**Coal Combustion Waste Impoundment
Round 7 - Dam Assessment Report**

Rush Island Power Station

***Ameren Missouri
Festus, Missouri***

Woody Vegetation

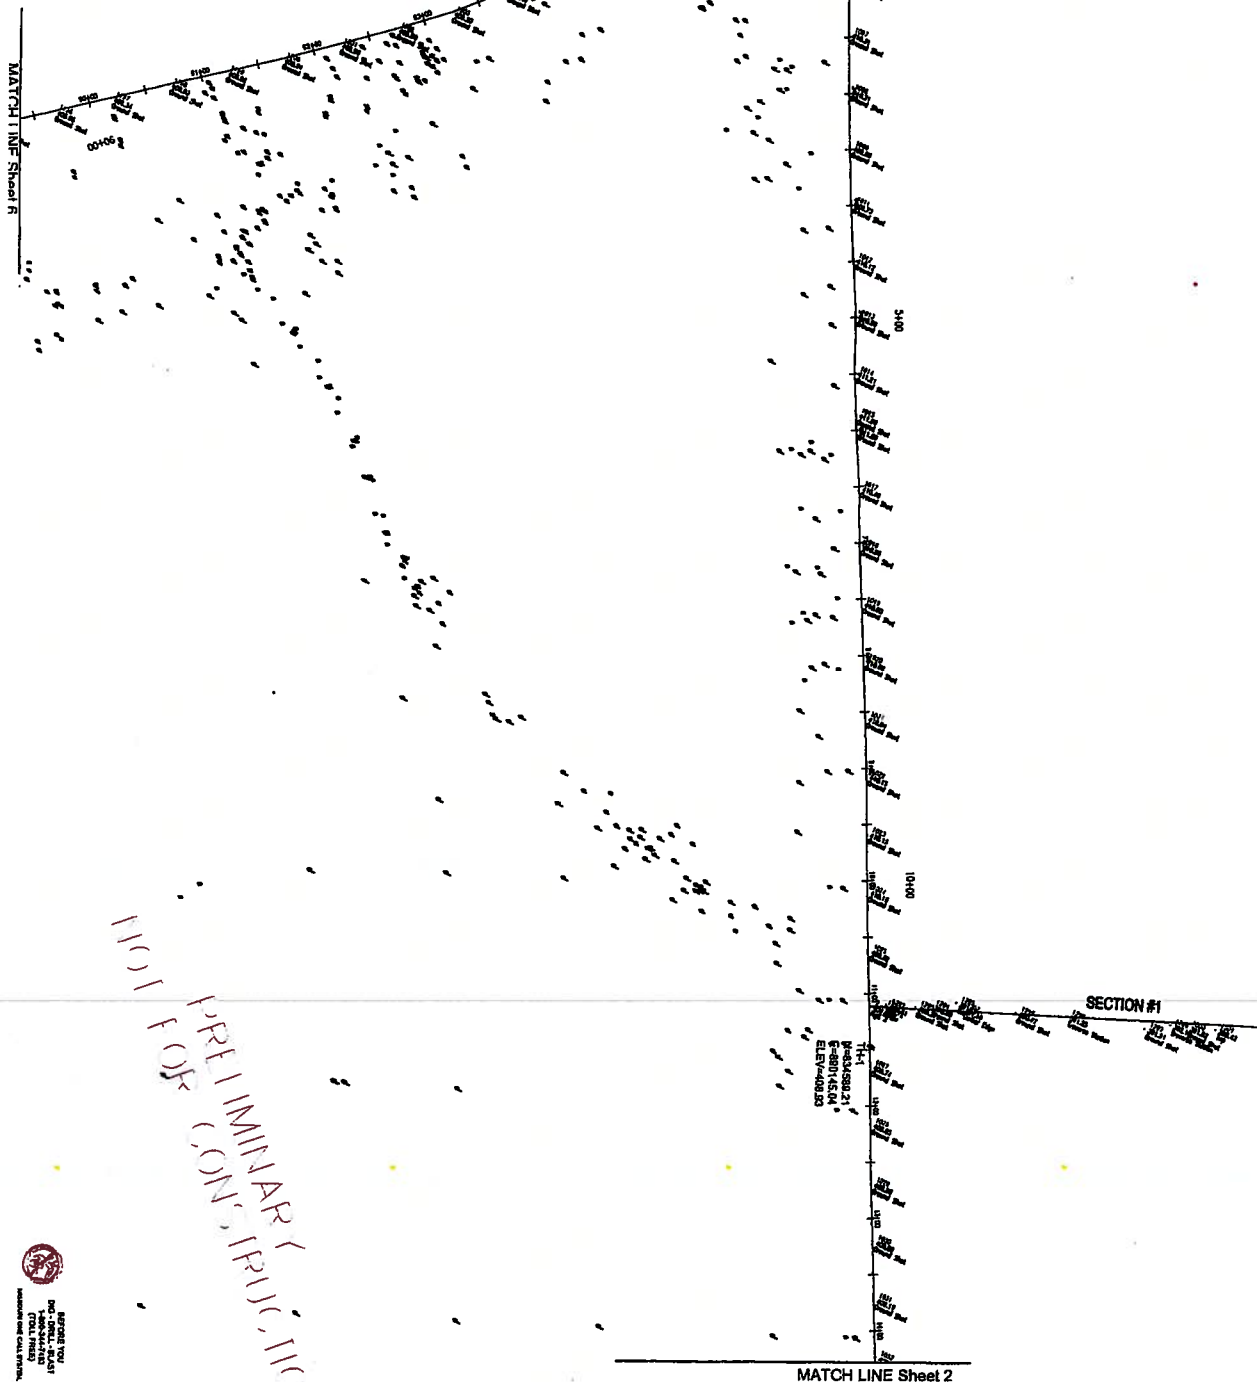
Woody Vegetation is establishing along the interior slope from approximately Stations 48+00 to about 55+00. This needs to be cleared.
